Attachment 3

MARKED-UP TECHNICAL SPECIFICATION PAGES

8812070189 881129
PDR ADOCK 05000275
P PDC

FIGURE 2.1-1a
REACTOR CORE SAFETY LIMIT

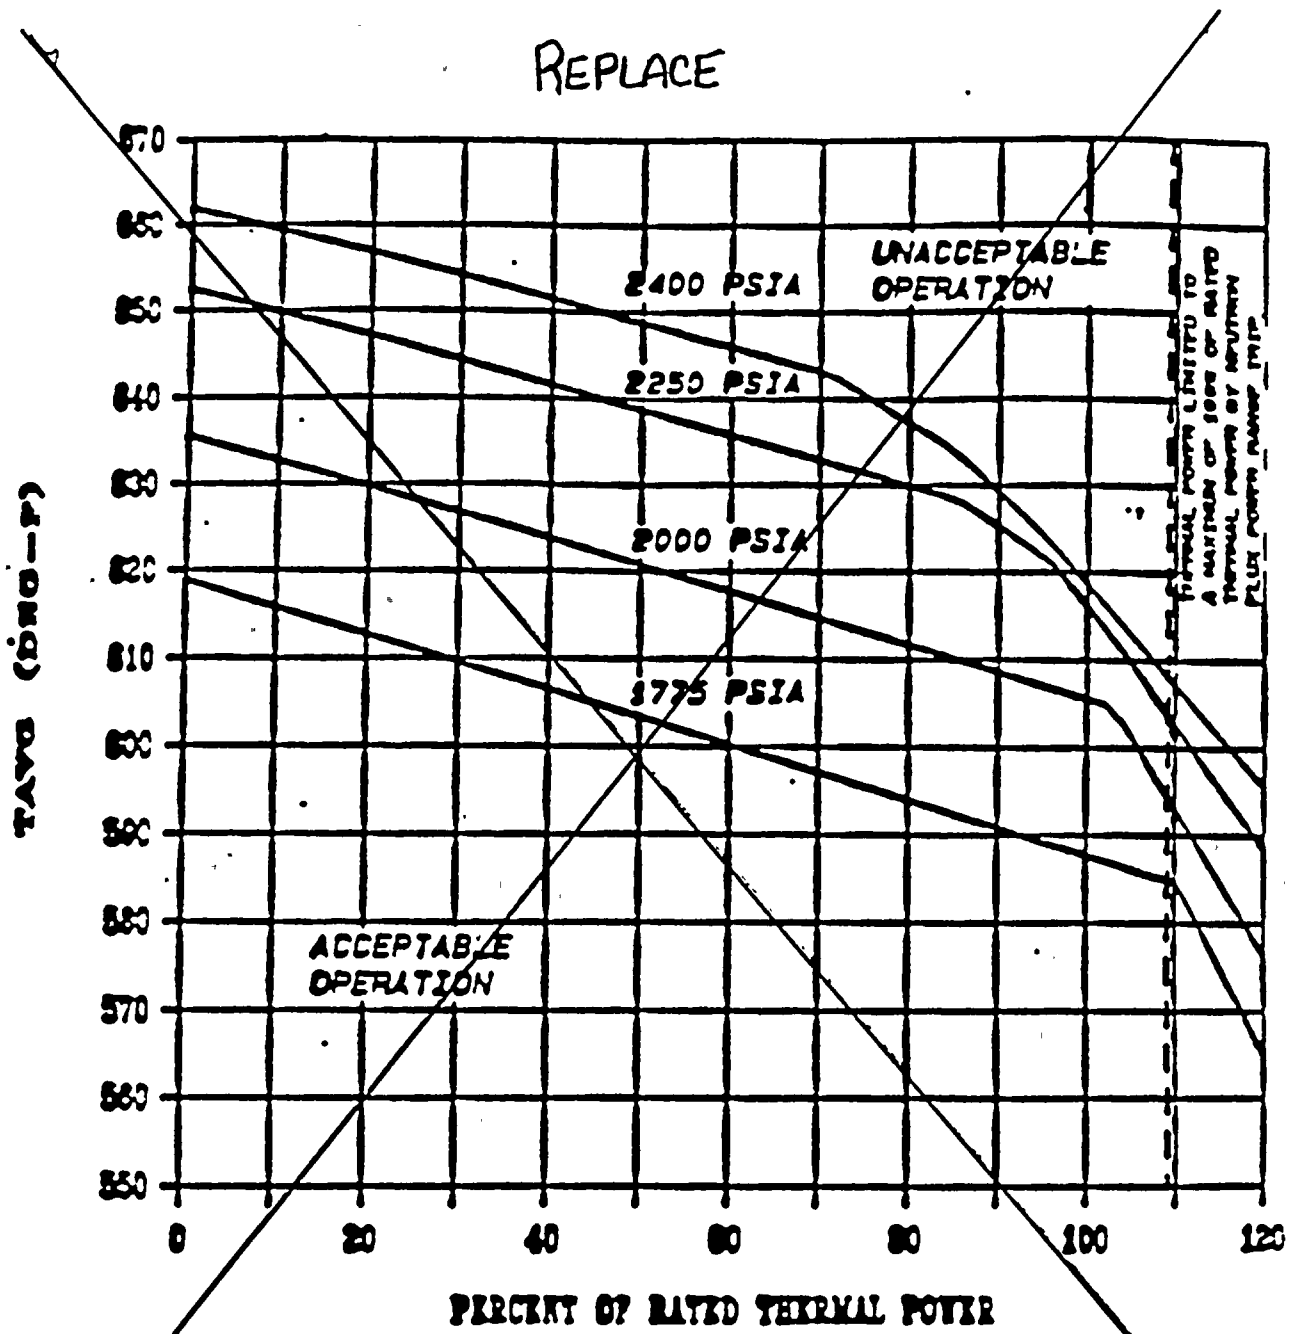
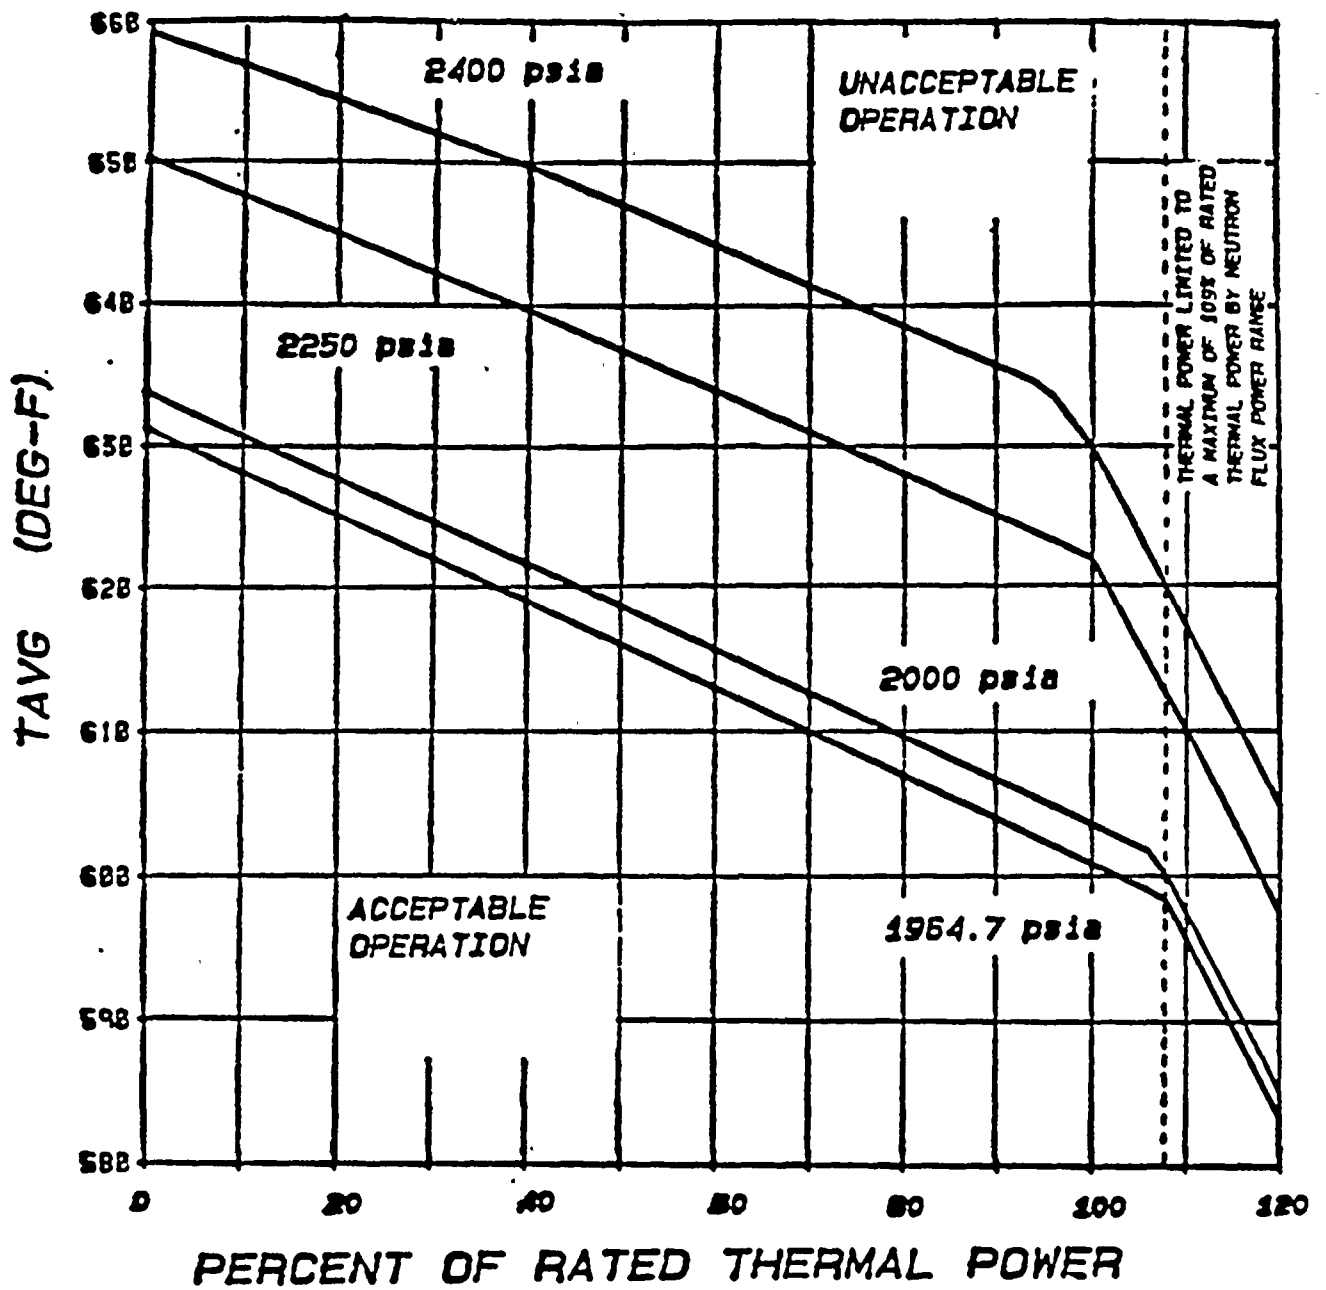
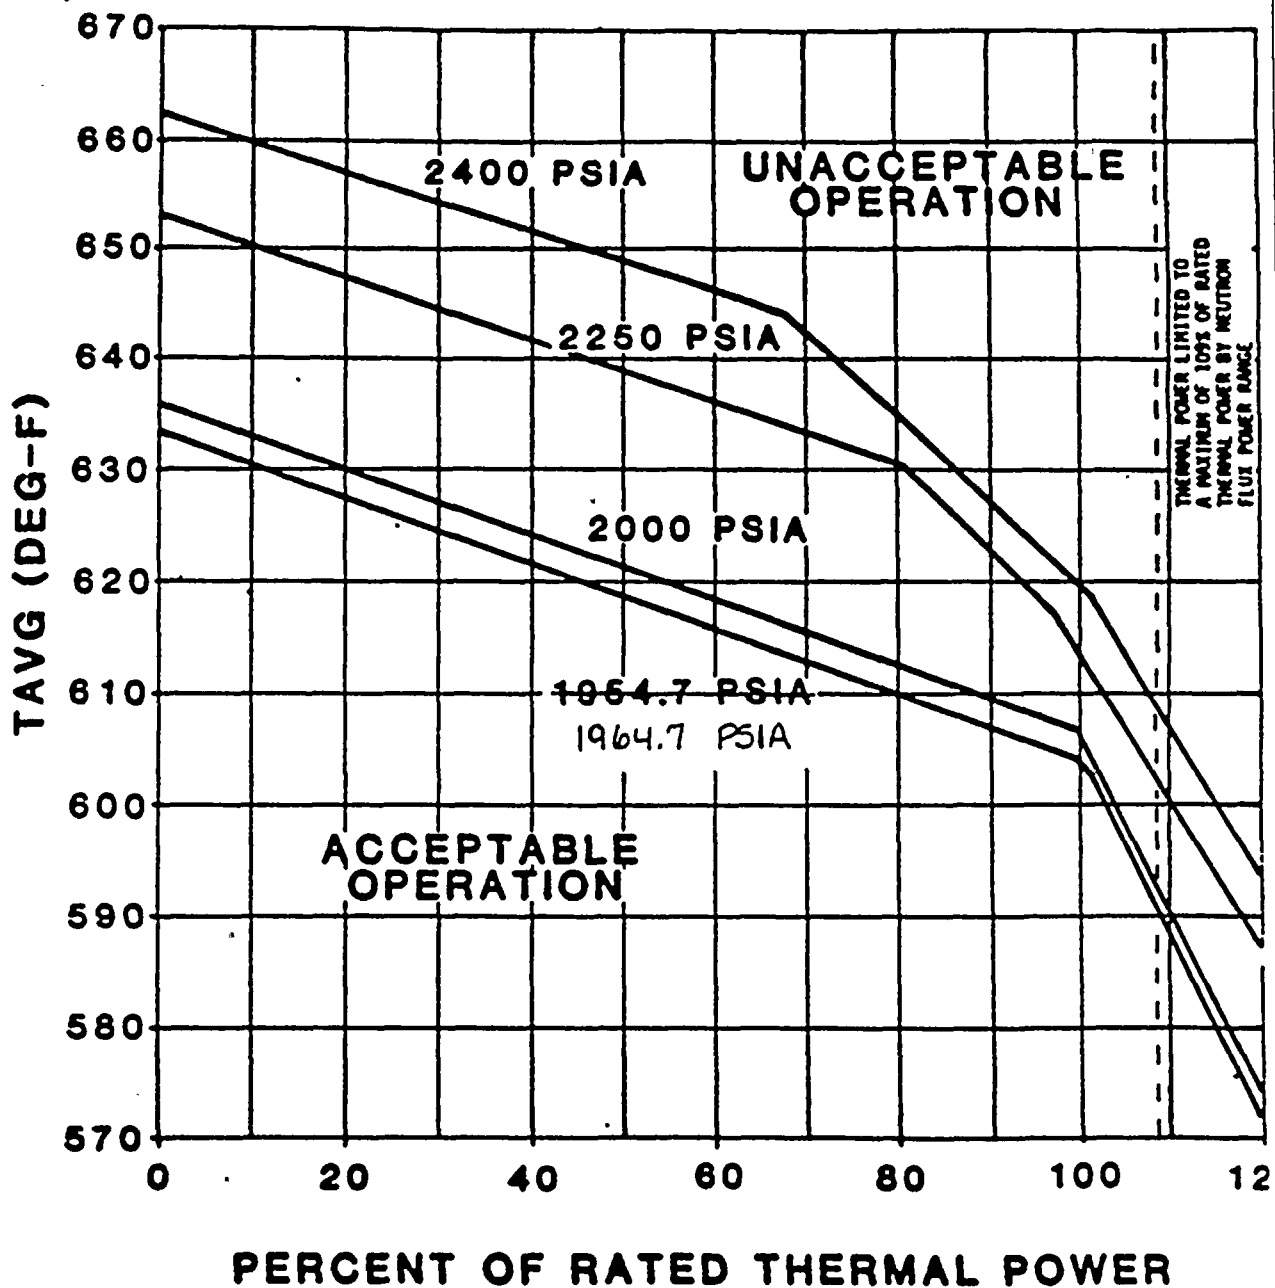
2.1.1 The combination of THERMAL POWER, pressurizer pressure, and the highest operating loop coolant temperature (T_{avg}) shall not exceed the limits shown in Figure 2.1-1a for Units 1 and Figure 2.1-1b for Unit 2, and 2, Cycle 4 and after Cycle 3

DIABLO CANYON - UNITS 1 & 2 Cycle 4 and after

FIGURE 3.2-1A
and 2 Cycle 4 and after
UNITS 1 AXIAL FLUX DIFFERENCE LIMITS
AS A FUNCTION OF RATED THERMAL POWER

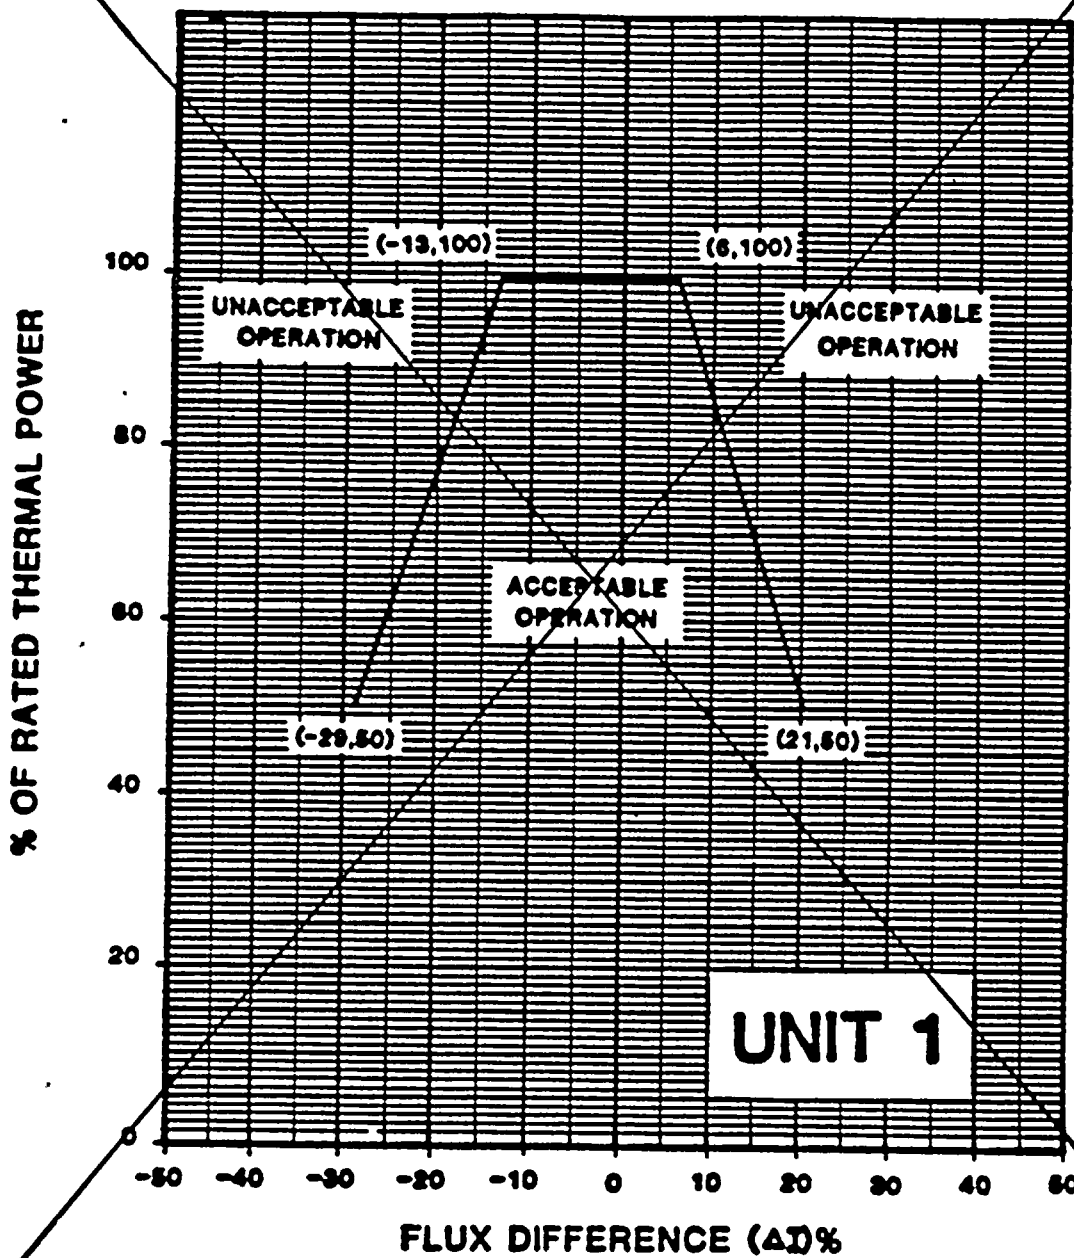
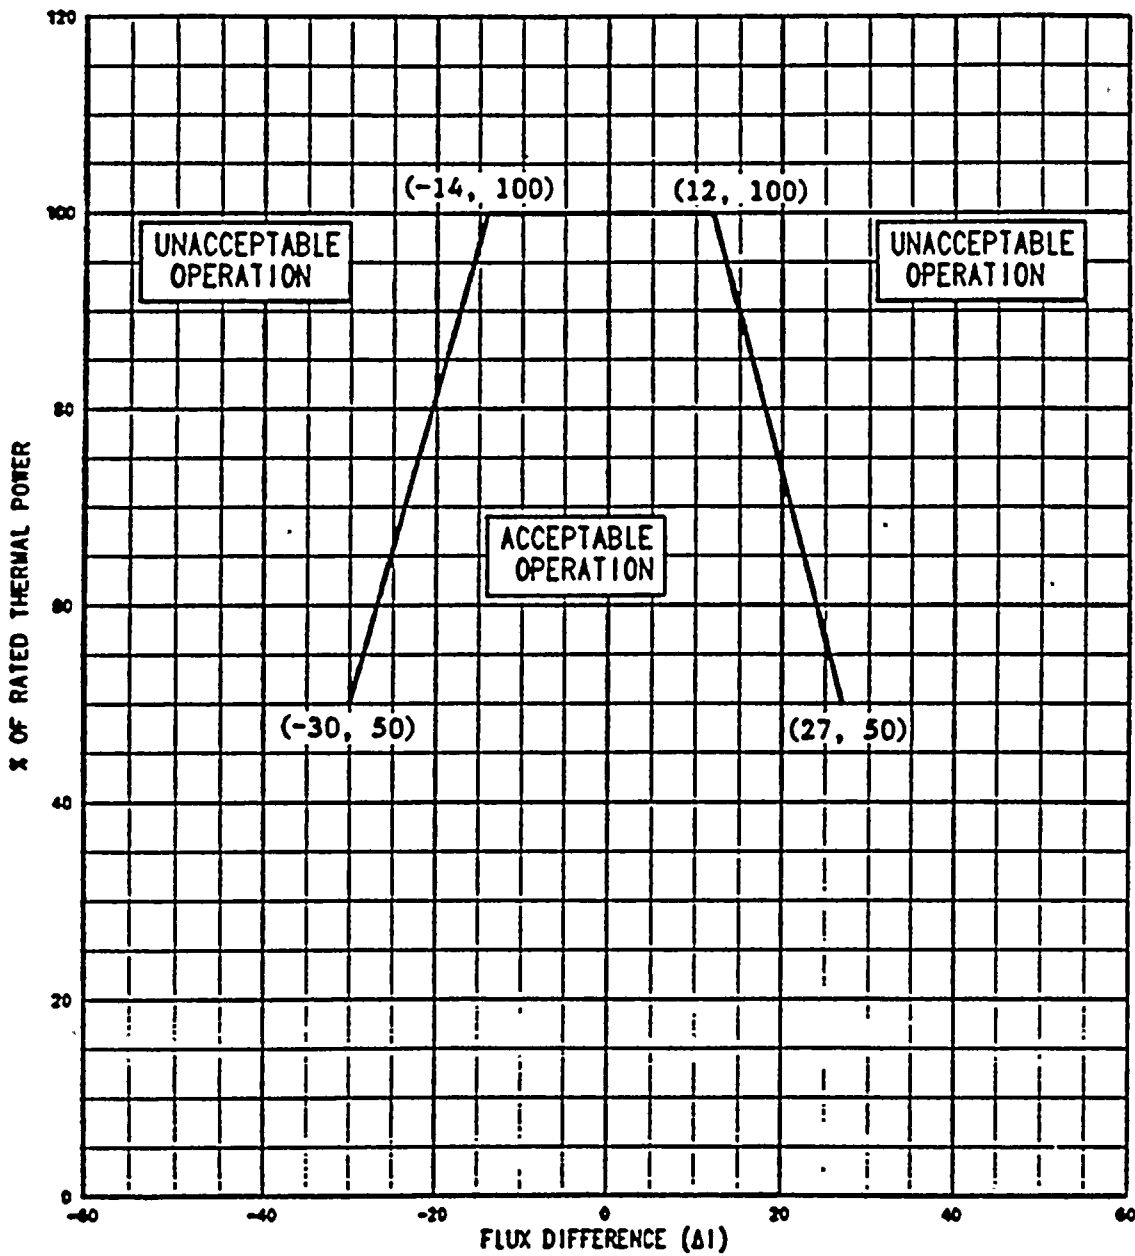
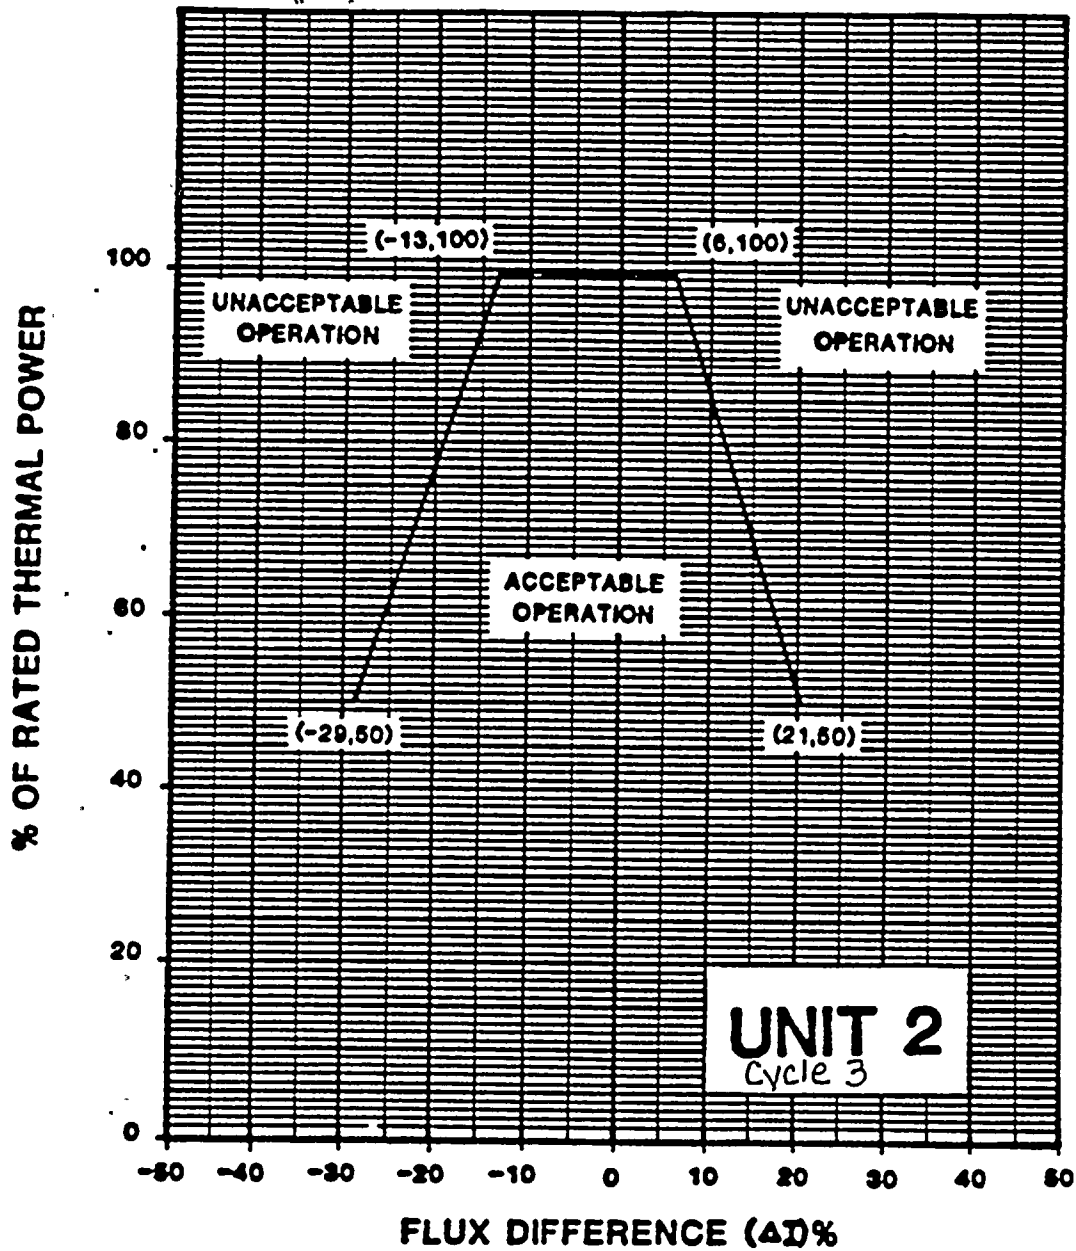
3.2.1 The indicated AXIAL FLUX DIFFERENCE (AFD) shall be maintained within the allowed operational space defined by Figure 3.2-1a for Units 1, and Figure 3.2-1b for Unit 2, ^{and 2 Cycle 4 and after} Cycle 3.

Replace
UNIT 1

UNITS 1 & 2 Cycle 4 and after
